August 15, 2023 Business Meeting Memo

SPR-22-0076: Van Matre Trust Residence

Request: Site Plan Review to deconstruct the existing residence and accessory structures before constructing a new 3,737 sq. ft. residence and 395 sq. ft. carport on a 1-acre parcel where the presumptive size maximum is 3,788 sq. ft.

Location: 1404 Wonderview Court

Figure 3: Existing site plan submitted with the original application materials indicating a 30' 6" setback for the existing residence, as well as similar setbacks on nearby parcels to the south.

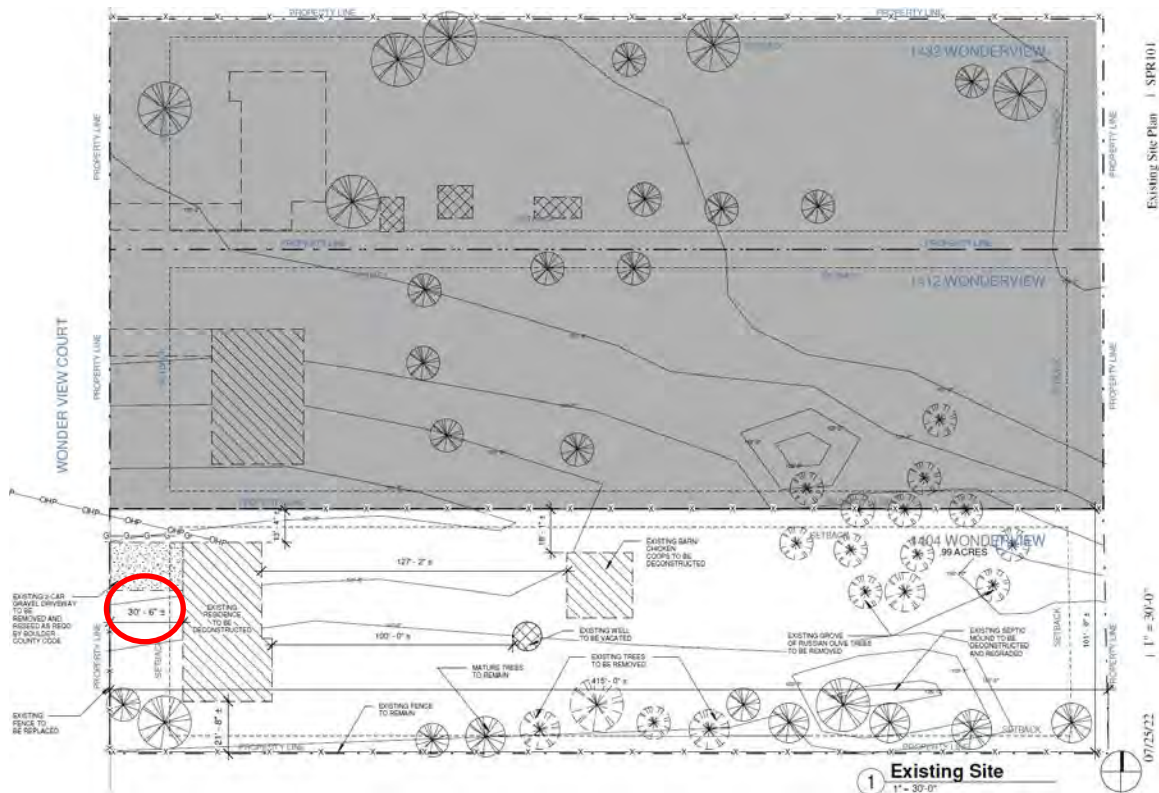
The submitted application materials include an existing site plan exhibit indicating that the existing (to be deconstructed) residence is located at an approximate 30' 6" setback from the western (front) parcel boundary (See Figure 3, below). The original proposal for redevelopment of the property indicated that the new residence would be located at a much larger setback of 137' 5" from the western parcel boundary.

Staff raised concerns that such a substantial setback would be significantly out of character with the existing pattern of development in the defined neighborhood, where nearly all of the residences are located very close to the front property line and have expansive rear yards.

The applicants contended that the substantial increase in front-yard setback was necessary to provide space for the required septic system drain field, which they stated should be on the western side of the residence in order to avoid negative impacts to the Sombrero Marsh to the east. As part of a revised application submittal, the applicants included a Site Evaluation and Engineered Septic System Design exhibit that dimensioned a septic system and indicated required setbacks from the system to other systems and wells on the subject and nearby parcels. The revised plans also included new elevations, and changed the proposed setback to the western parcel boundary from 137' 5" (original proposal) to 130' 1" (revised proposal).

Staff still have significant concerns regarding the substantial change in the setback between the residence and the western parcel boundary because the predominant pattern of development within the defined neighborhood places residences much closer to the front property line than has been proposed by the applicant. The proposed location would conflict with the visual character of the defined neighborhood and is a cause for concern related to impacts on the Sombrero Marsh as described in the BCPOS referral response.

Grading Plan | SPR104

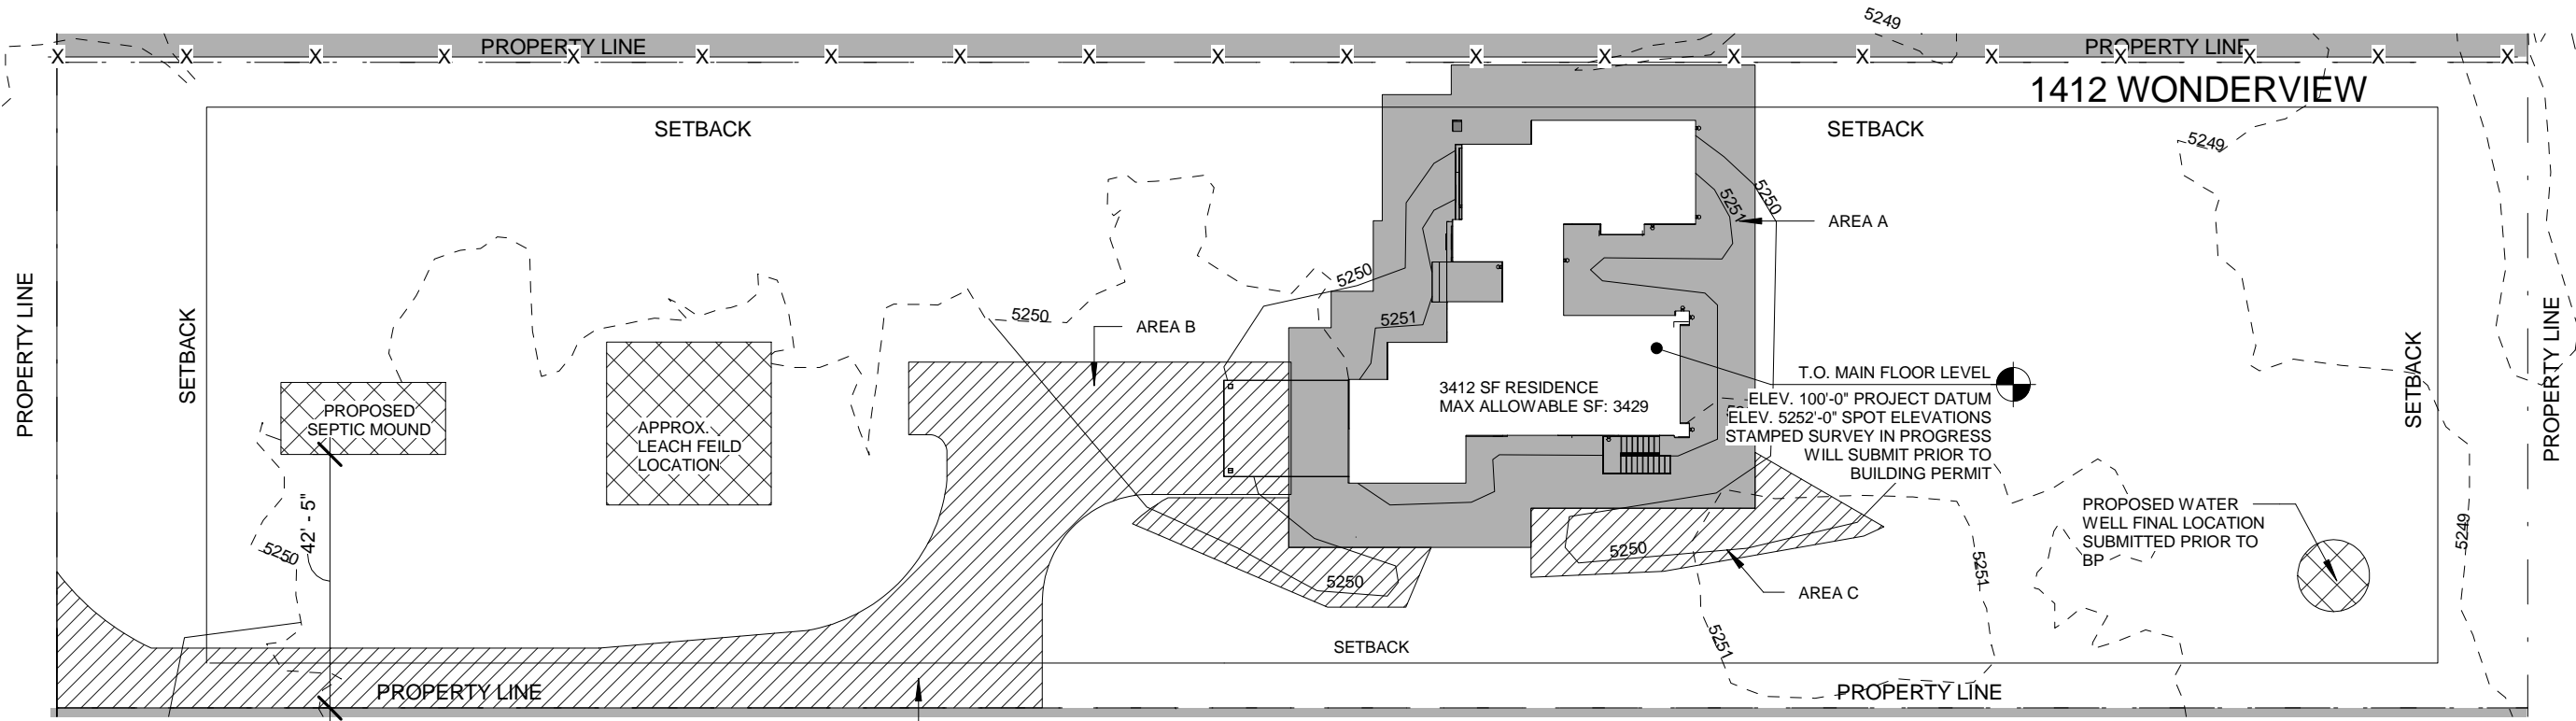
4. The revised grading plan submitted on 2/14/2023 (attached) indicates 97.72 cubic yards of fill will be used along the driveway. The improved driveway must comply with the [Boulder County Multimodal Transportation Standards \(“the Standards”\)](#) for residential development, including without limitation:
 - a. Table 5.5.1 – Parcel Access Design Standards (1-Plains Access)
 - b. Standard Drawings 11 -12 – Private Access

per standard drawing 12 found in the Standards, Therefore, a Design Exception Request is required.

Approximate location of proposed house looking south to 1432 Wonderview

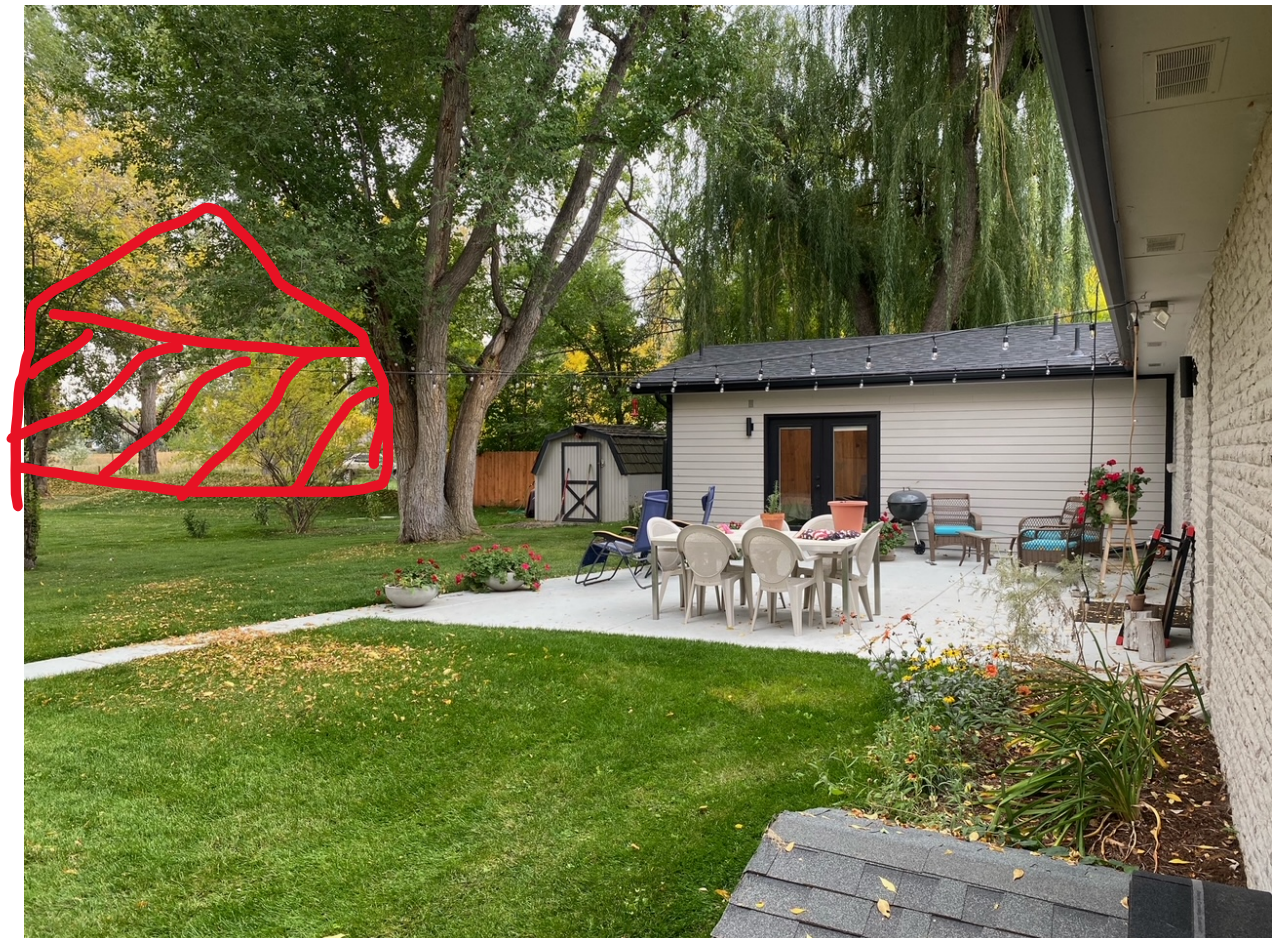
OPEN SPACE IMPACTS - As noted in the Boulder County Open Space response this is a very unique area which supports a healthy aquatic ecosystem full of birds. Additional light and glare close to the marsh will have a negative impact on the wildlife.

To be consistent with Boulder County Standards (2, 4, 10 & 14) and the goals of the Boulder Valley Comp Plan, the house location should be denied. The replacement structure should be placed on or near the existing house.
